Subject: Response to Request for Additional Information Regarding License Amendment  
Application for Measurement Uncertainty Recapture Power Uprate  
(License Amendment Request No. 05-0007) (TAC No. MD5240)

## RESPONSE TO REQUEST FOR ADDITIONAL INFORMATION

### DAVIS-BESSE NUCLEAR POWER STATION, UNIT NO. 1

### Loop A Gain (<76 dB)

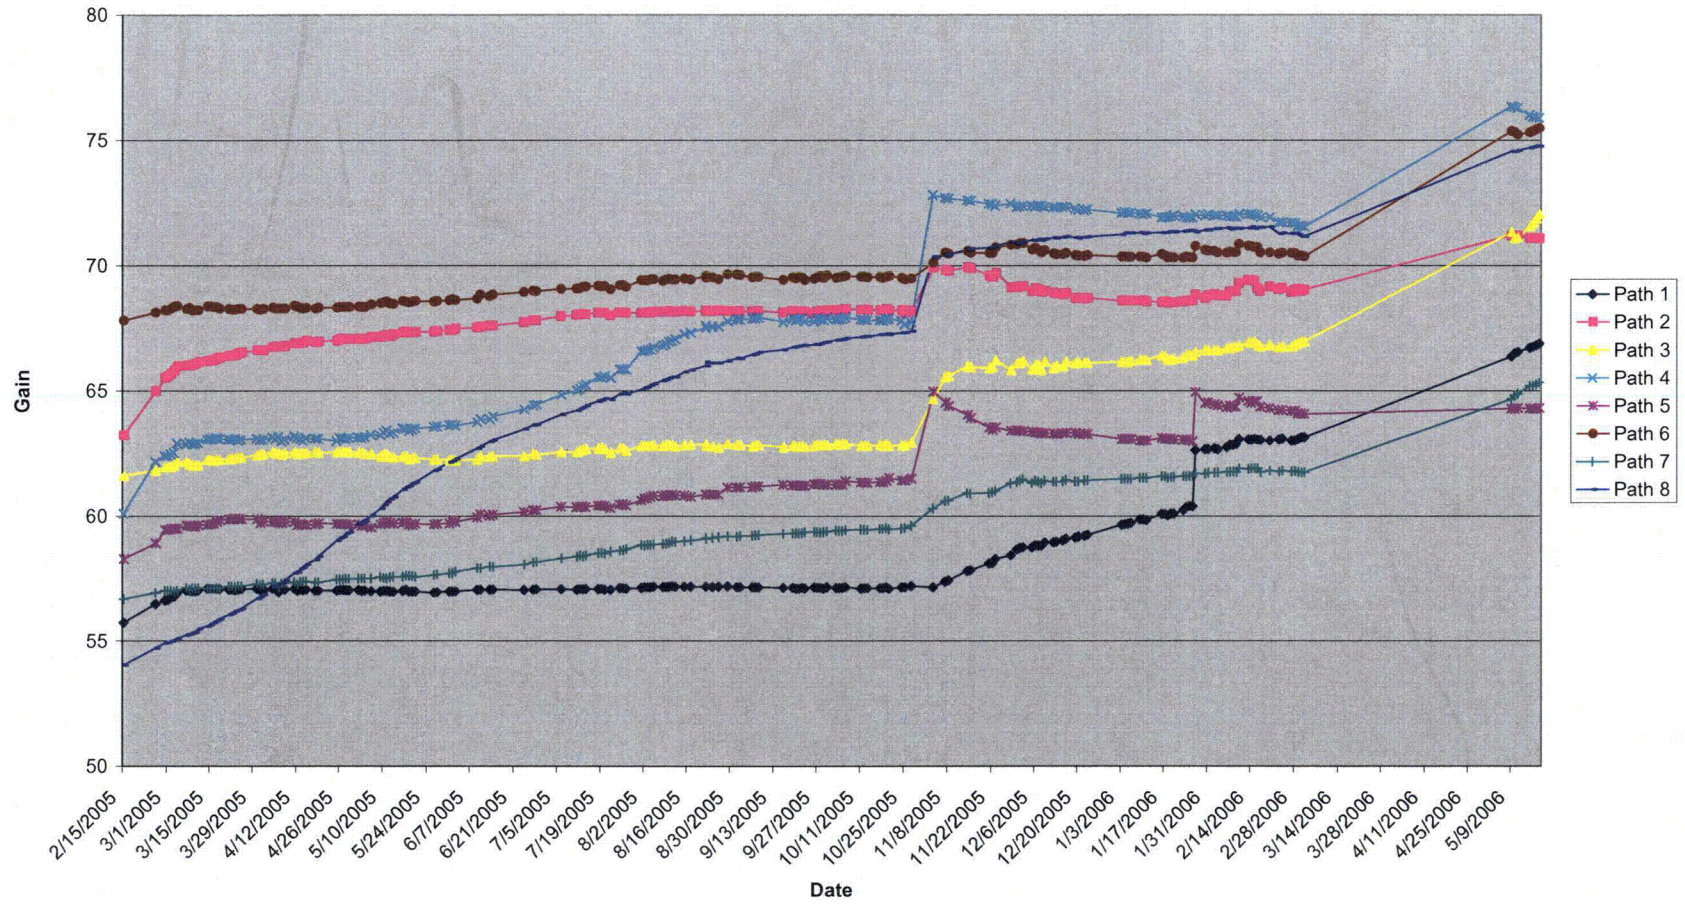
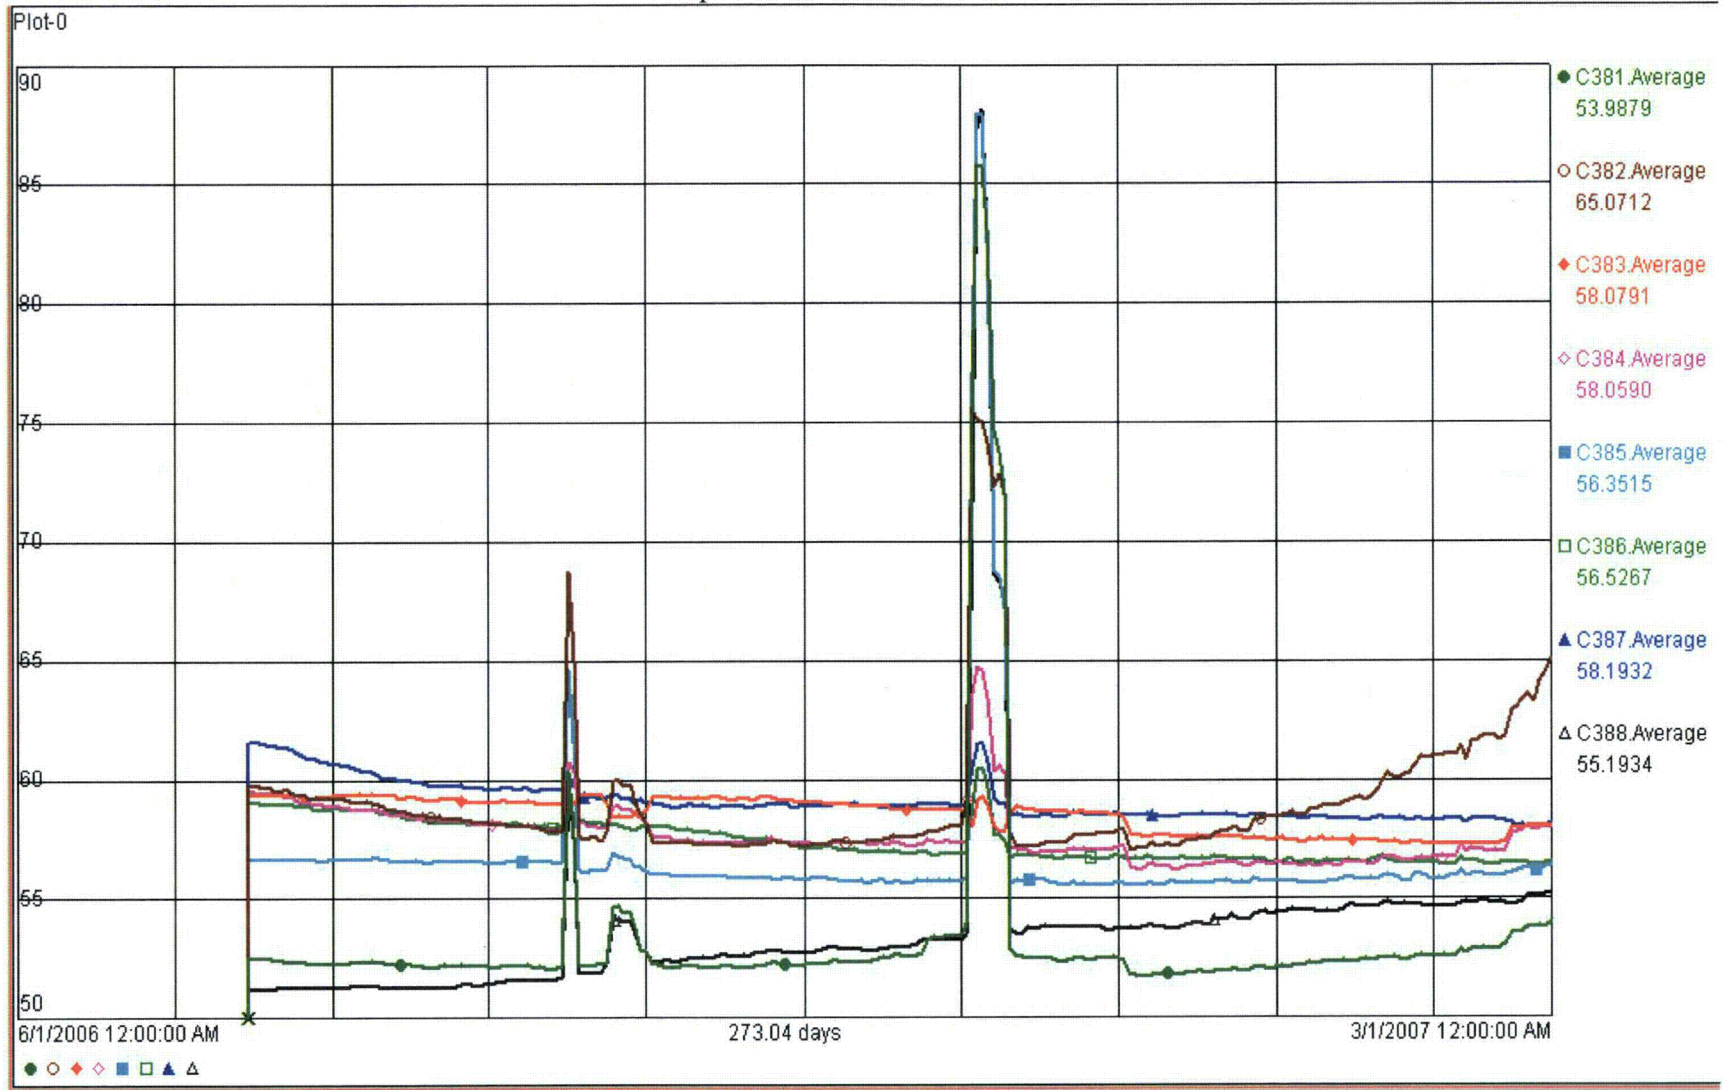
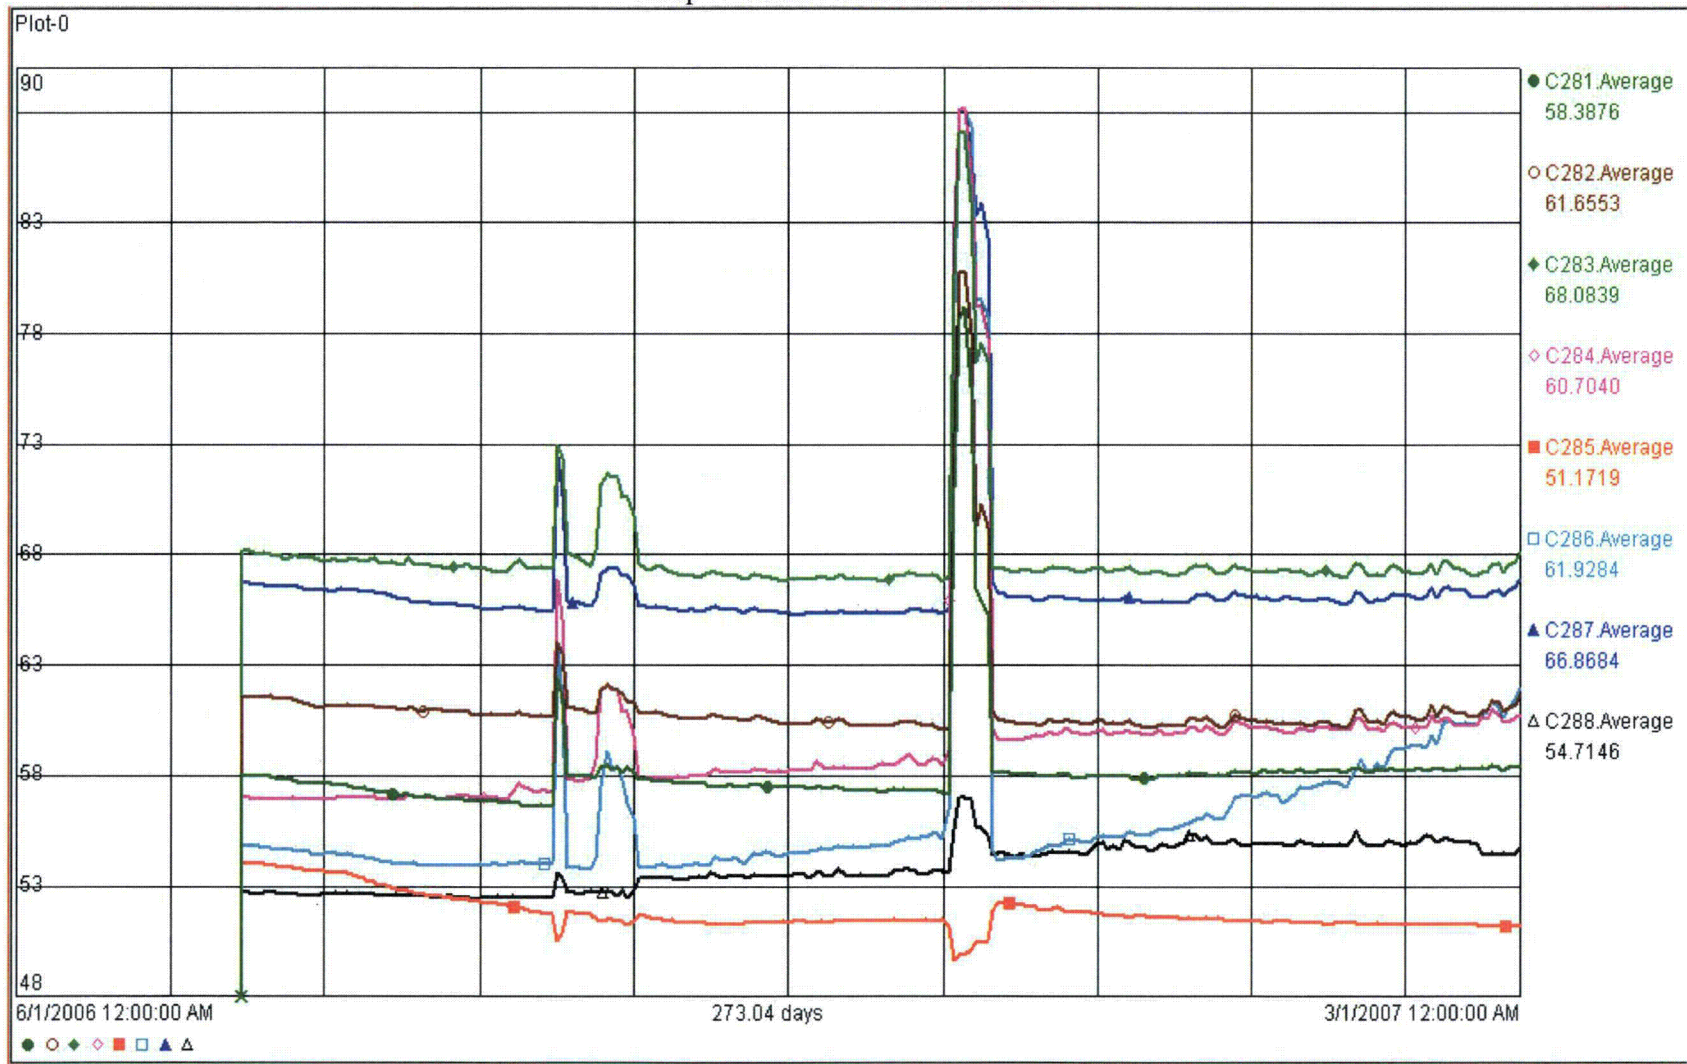
**23. SRXB: Please provide a summary of LEFM characteristics before and after replacement of the 32 transducers in June 2006. This summary should contain a comparison to other feedwater measurement instruments over a sufficient time span to enable a valid comparison of before and after characteristics.**

The gains of the individual pathways of the LEFM were chosen for review due to their trends indicating the overall health of the transducers. The higher the gain, the greater the amplification of the signal required to ensure an accurate flow measurement. A review of the gains prior to and after June of 2006 shows a definite improvement in gains after the transducers were changed out in June of 2006. This is expected due to the fact that the original transducers had approximately six thermal cycles on them, which is the major aging mechanism for the "F" revision of the transducers. The data shows that changing out the transducers to the "K" revision did not have an identifiable impact on the performance of the LEFM other than what was expected. On the graphs of the gains prior to June of 2006, the upward shift in gains is due a plant maintenance outage and the downward spikes in gains were due to 14RFO. The spikes on the graph after June of 2006, were due to plant maintenance outages.

In summary, there were no identifiable effects observed in the data due to changing out of the transducers in June of 2006. Data was collected on the performance of the transducers after the change out and verified by Cameron that the LEFMs were performing within specifications.
